Washington Public Power Supply System

RESPONSE TO THE SECOND ROUND OF
QUESTIONS ON TOPICAL REPORT WPPSS-FTS-129

Figure 2

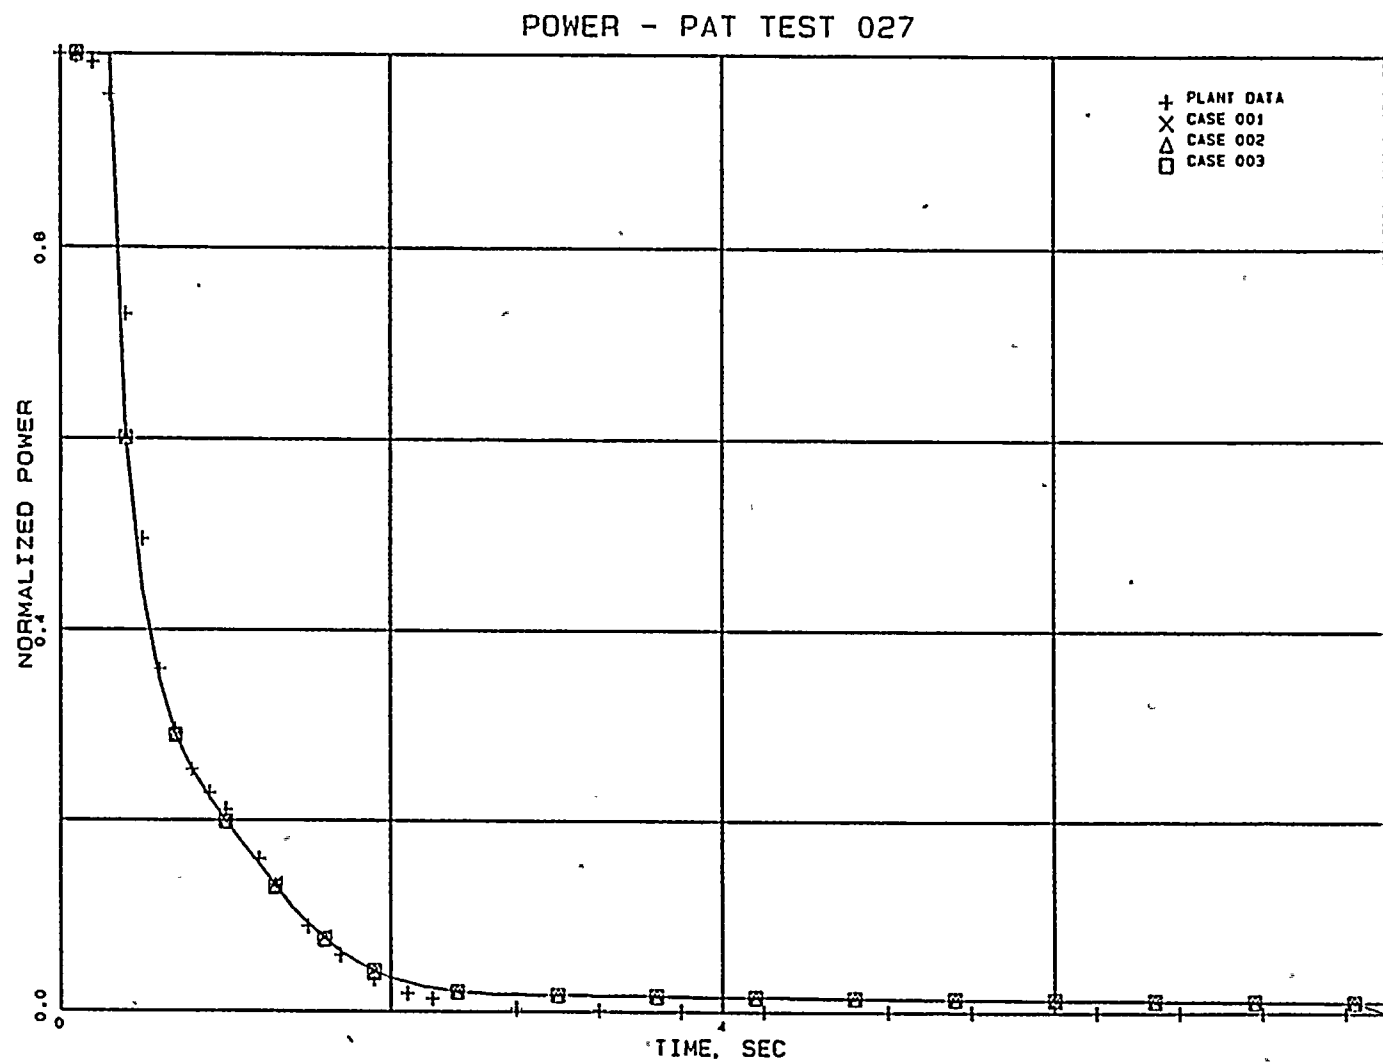
Provide a summary of the sensitivity analysis performed on core nodding for the limiting transients.

The sensitivity case was run and the results are given in Figures 2 through 7. Since Power Ascension Test (PAT) 027 simulates the load rejection which is limiting in the licensing basis model, it was selected as the case for this sensitivity study. Figure 2 gives the power versus time. Four different data points were plotted in the figure. Plant data is from the measured APRM signal in percent power. Case 001 data is the RETRAN results based on a transient initiated from the rated condition (same results as presented in Reference 1). Case 002 is the RETRAN results based on a transient initiated from the actual plant steady-state condition at the initiation of the test (see Reference 2). It should be noted that in Reference 2, Table 1.7-1, the system pressure for PAT 027 was mistakenly quoted as 1014.7 psia. It should be 999.7 psia. The corrected value is given in Table 1. Case 002 presented in this document reflects this correction. Case 003 is the same as Case 002 except that the number of core nodes is increased from 12 to 24. As seen in Figure 2, the 24-node case yields essentially the same

The capability of the model in predicting the scram worth correctly is verified through the close match of the RETRAN calculated power with the measured data after scram in PAT 027 (see Figure 2).

Figure 9

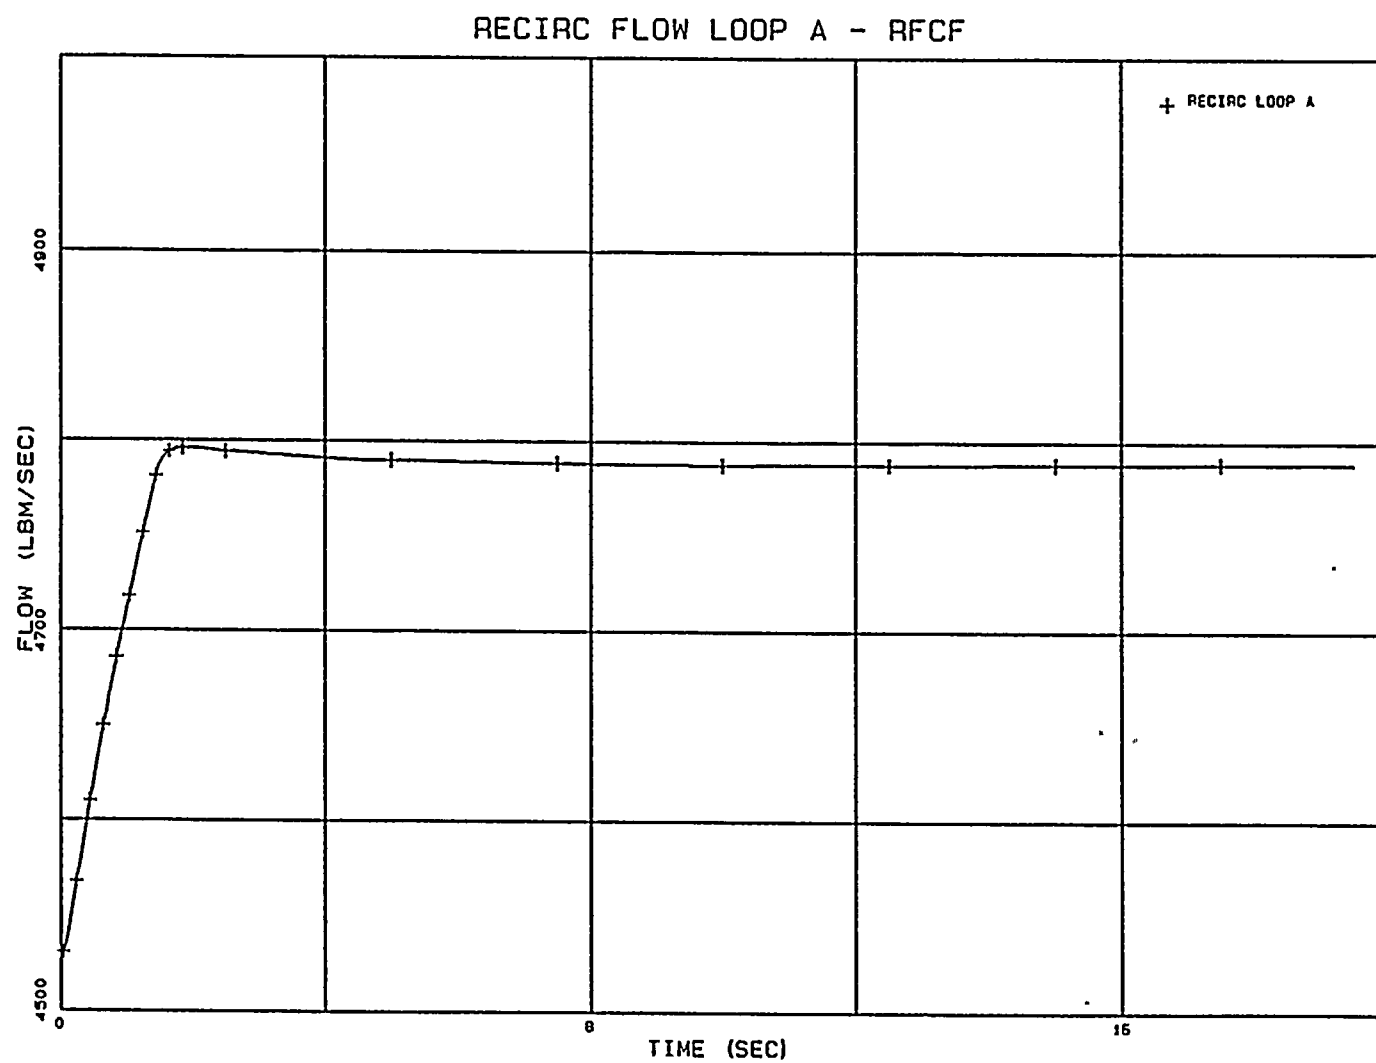
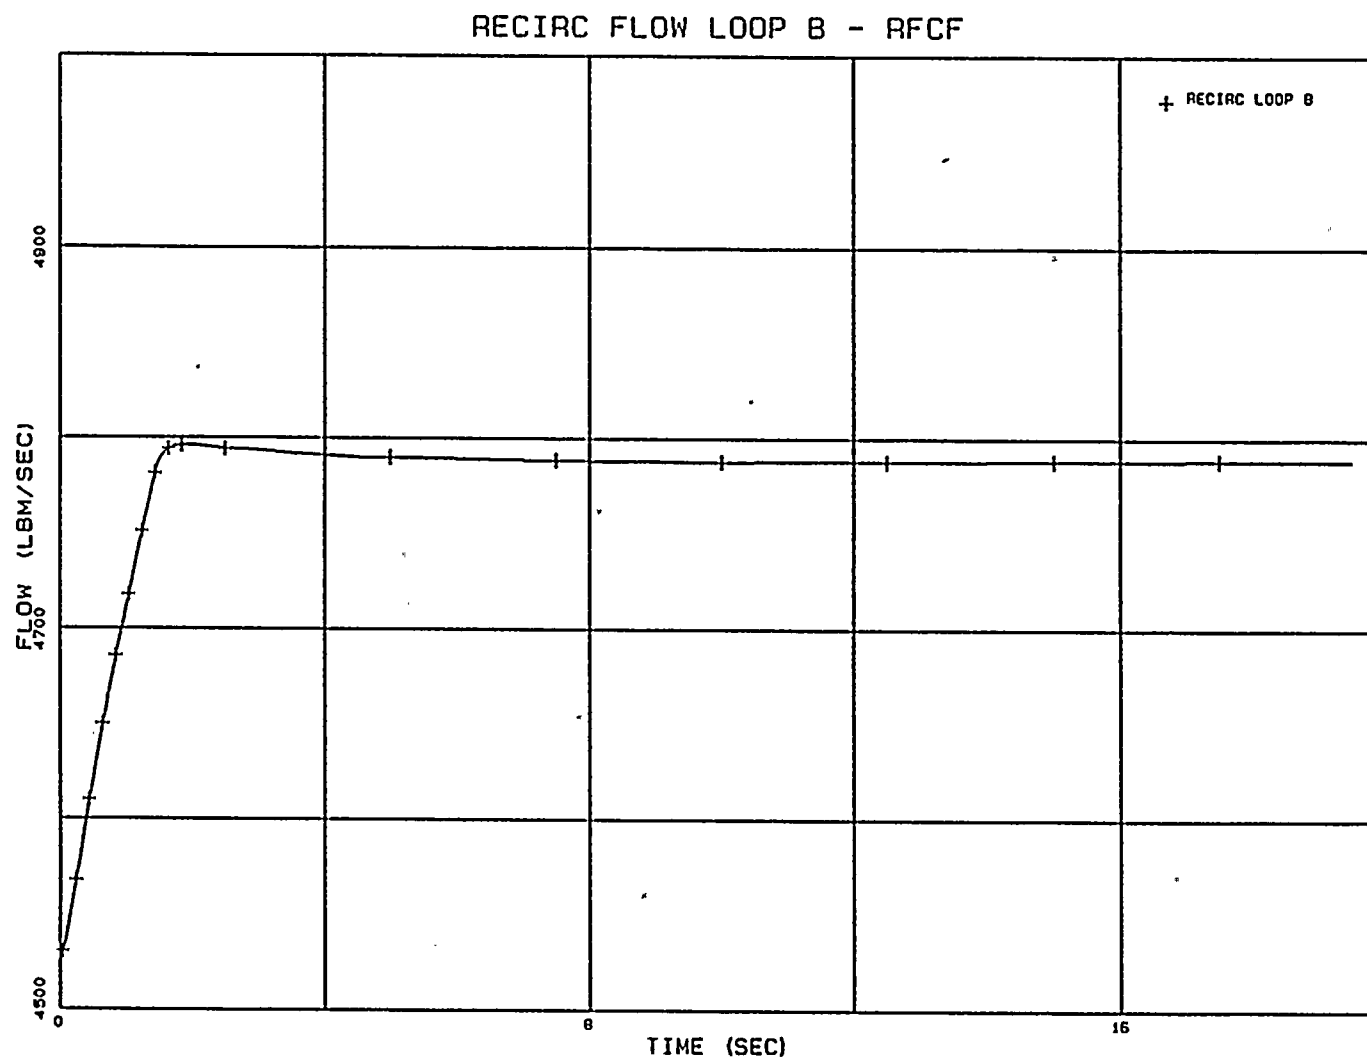
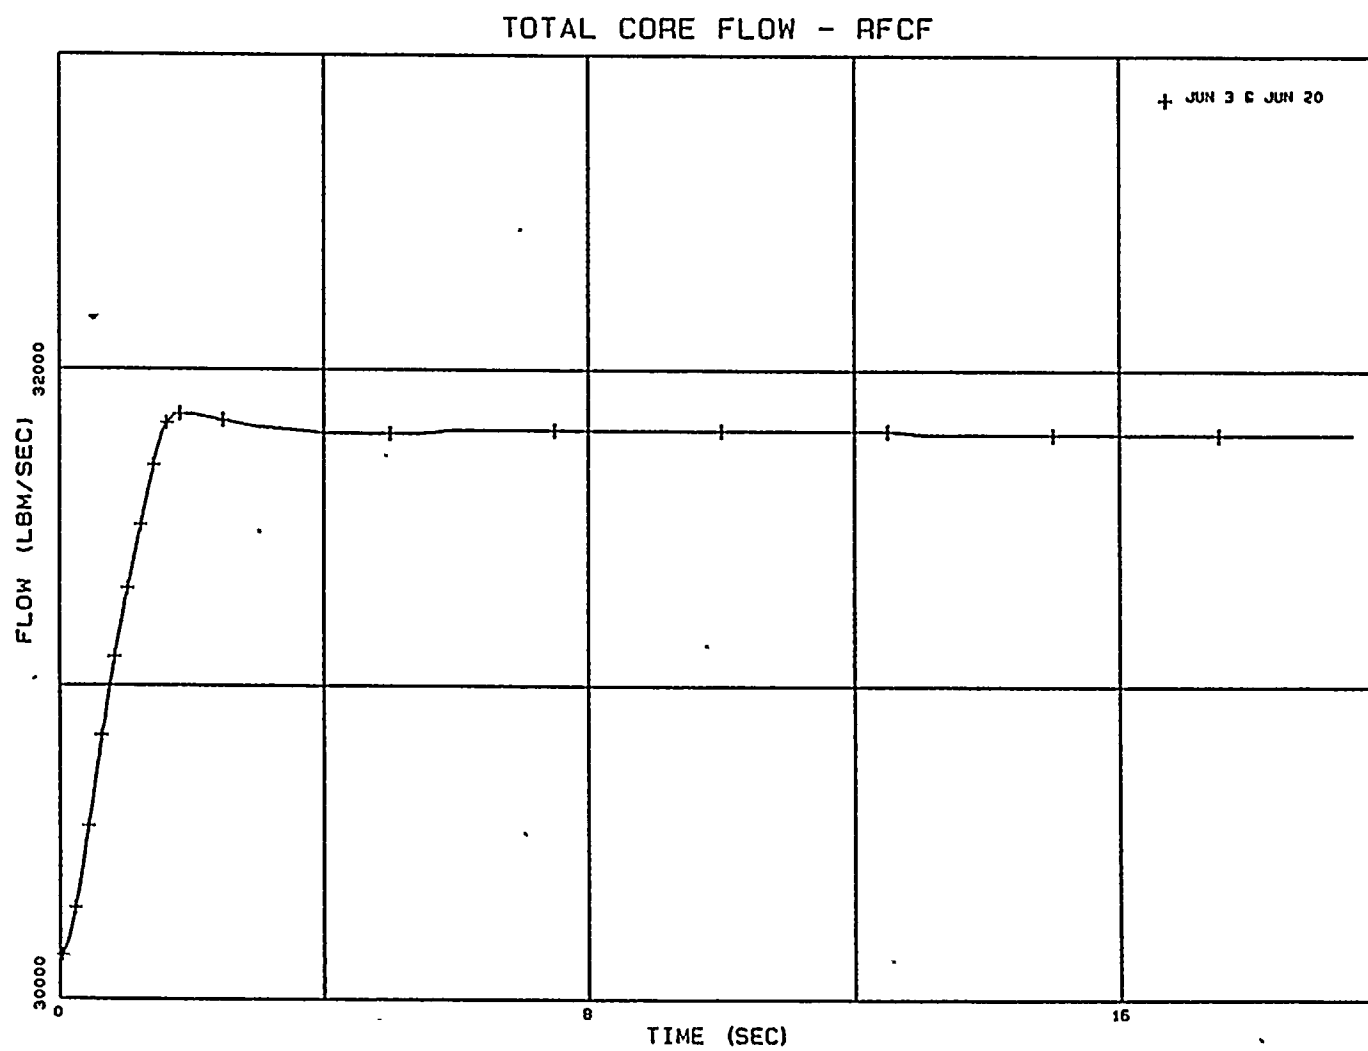
Provide justification for using a single nodalization scheme for all of the transients instead of different nodalization schemes for different transients.

Figures 9 and 10 show the recirculation flows for loops A and B. As in Response to Question 1, the RETRAN code simulated a symmetrical behavior for both loops as expected. Figure 11 gives the total core flow which follows the recirculation pump flow closely. As the core flow increases, the void fraction decreases. This is shown in Figures 12 and 13. The void collapsing leads to a power increase as shown in Figure 14. This increased power tends to increase the void fractions, which will in turn slow the increase in core power. As the recirculation flow stabilizes at a new level, the core power and the void fractions will reach a new steady state as shown by the plotted results.

Figure 17

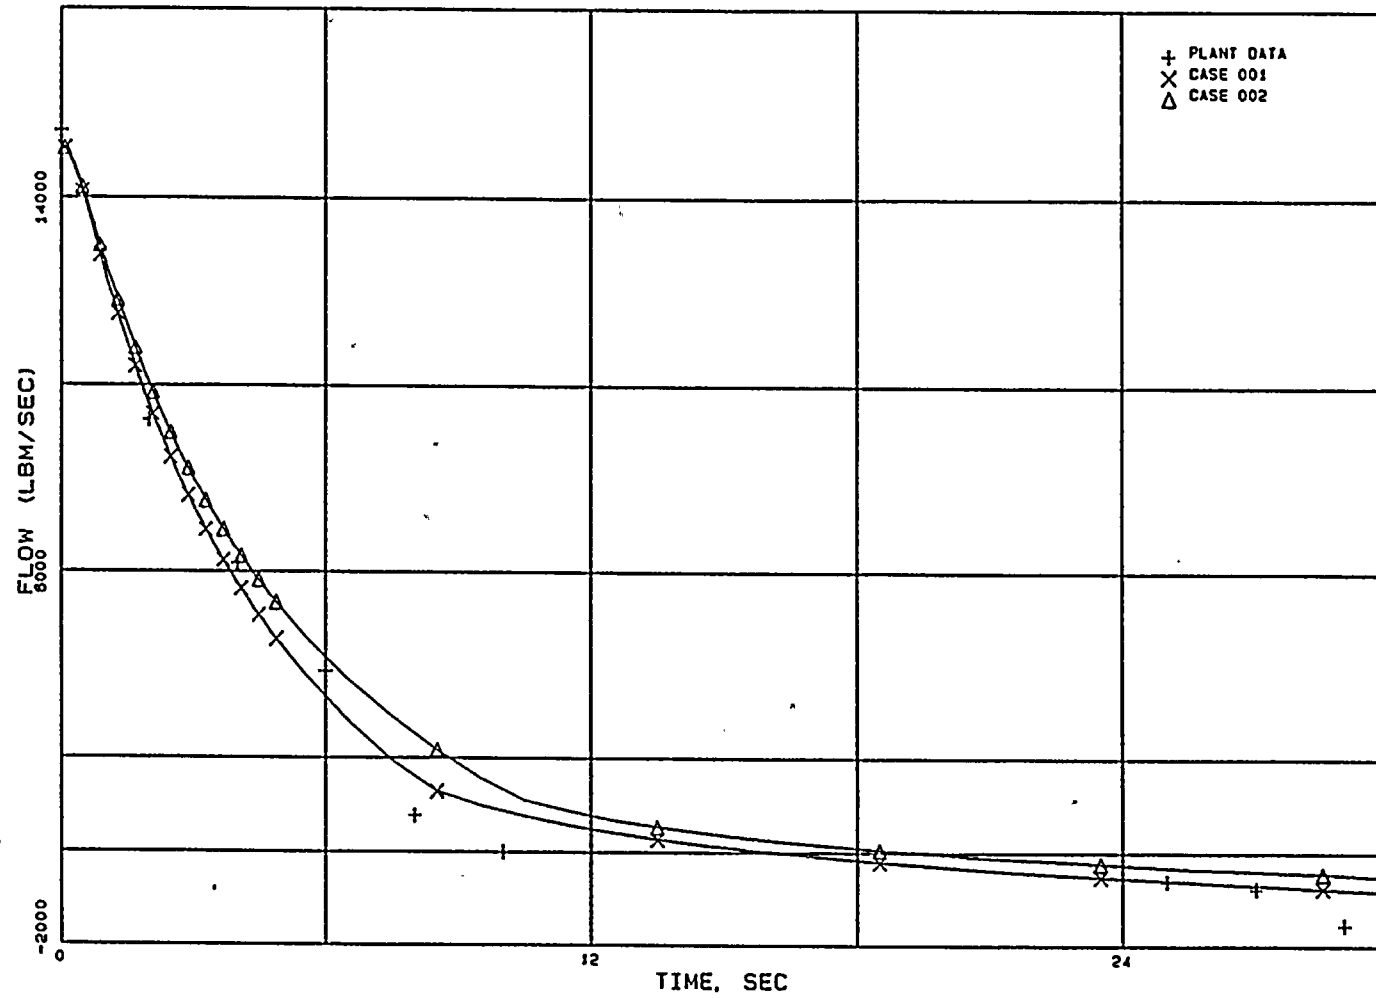
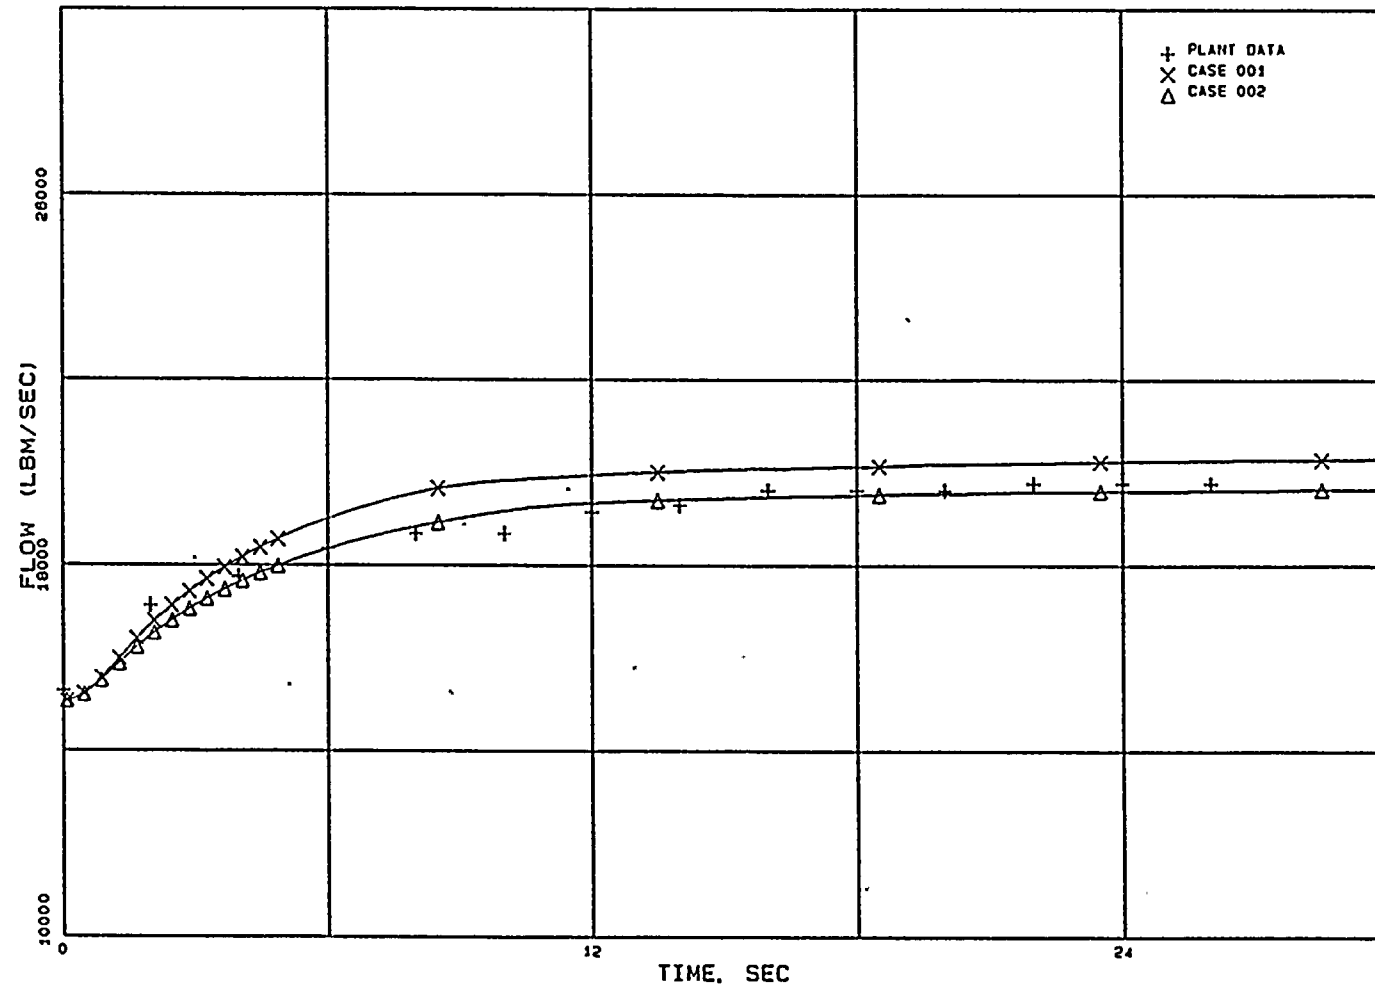
Redo RETRAN simulation for PAT Tests 30A and 027 using the actual plant initial conditions instead of the rated conditions and discuss the impact of the changes. The RETRAN code used should have the correction on recirculation pump flow symmetry. In addition, the results should be compared to the plant data in a non-normalized form.

Figures 17 and 18 show the jet pump flows (sum of driving and suction flows) for Loops A and B respectively. The behaviors are very similar to the recirculation flow comparisons. The revised calculation for the unaffected loop gives a closer comparison with the plant data. The coast down rates for the tripped loop for Cases 001 and 002 (Figure 17) are slightly different. Case 002 gives a slower coast down rate than Case 001. The difference is mainly caused by the differences in the driving flows as shown in Figure 15. If the two RETRAN curves in Figure 15 are normalized so that they start at the same value, the Case 002 curve will show a slower coast down rate than Case 001. As the driving flow increases or decreases, the suction flow will also increase or decrease. Thus,
